Amendment 39-5521; **AD 87-03-08**

Airworthiness Directives; Taylorcraft Models BC, BCS, BC-65, BCS-65, BC12-65 (Army L-2H), BCS12-65, BC12-D, 19, F19, F21 and F21A Series Airplanes

FIGURE 1 AD 87-03-08

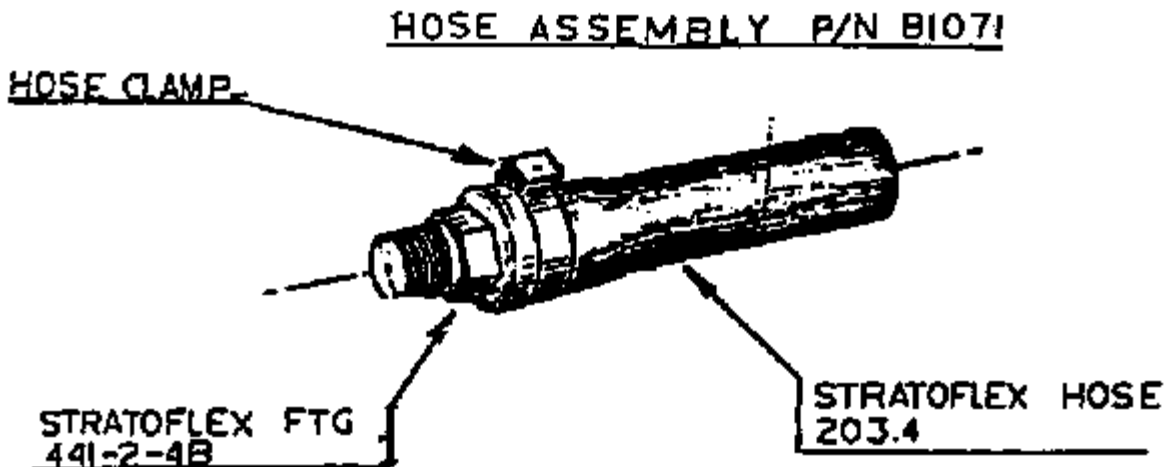
(a) Visually inspect the oil pressure gauge hose assembly at the engine to determine whether the type of hose assembly installed is P/N B7071. (See Fig. 1)

(1) If the oil pressure hose assembly is not of the type illustrated in Figure 1, no further action in accordance with this AD is required.

(2) If the oil pressure hose assembly is of the type illustrated in Figure 1, prior to the next flight, replace with a new P/N B7071 hose assembly identified by Taylorcraft with a "T" stamped on one of the wrenching flats on one of the hose assembly brass fittings.
